Office Action Summary

09/964,639

KIM, DONG-GYU

DETAILED ACTION

FIG. 3

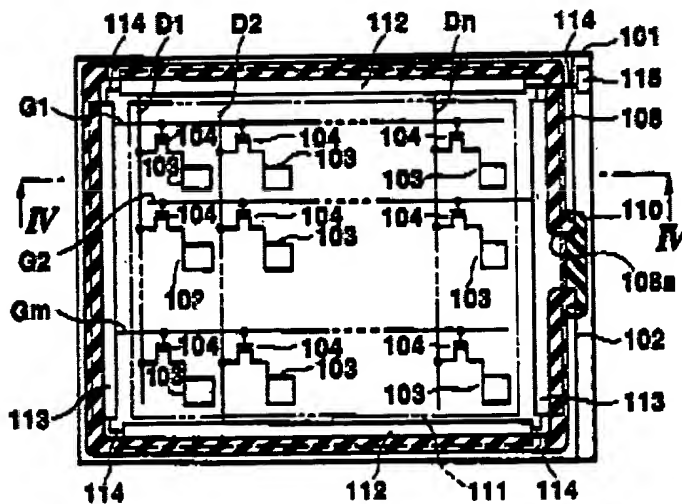
3. Sawatsubashi discloses and shows in Fig. 3, a display device, comprising:

- a first substrate having a plurality of gate lines (G1-Gm) and a plurality of
- data lines (D1- Dn);

- a plurality of thin film transistors (104) electrically connected to the gate lines and the data lines;
- a plurality of pixel electrodes (103) electrically connected to the thin film transistors respectively;
- a plurality of gate driving ICs (113) to output gate signals to the gate lines;
- a plurality of data driving ICs (112) to output data signals to the data lines;
- and
- a plurality of signal lines (114) (applicant's interconnection lines) apply gate control signals to at least one of the gate driving ICs (145) (col. 5, lines 1-16).

Sawatsbashi differs from the instant invention because he does not explicitly disclose the claimed black matrix overlapping at least one of the interconnection lines.

It is common and known in the art to form black matrix on a substrate opposite to the substrate where the gate lines and the data lines are formed and outside the display area (interconnection lines are typically formed outside the display area) so that it overlaps the interconnection lines in order to prevent light leakage and thus improve display quality.

Therefore, it would have been obvious to one of ordinary skill in the art at the time of the invention was made to modify the display device of Sawatsbashi by forming

a black matrix such that it overlaps the interconnection lines so that light leakage is prevented and display quality is improved.
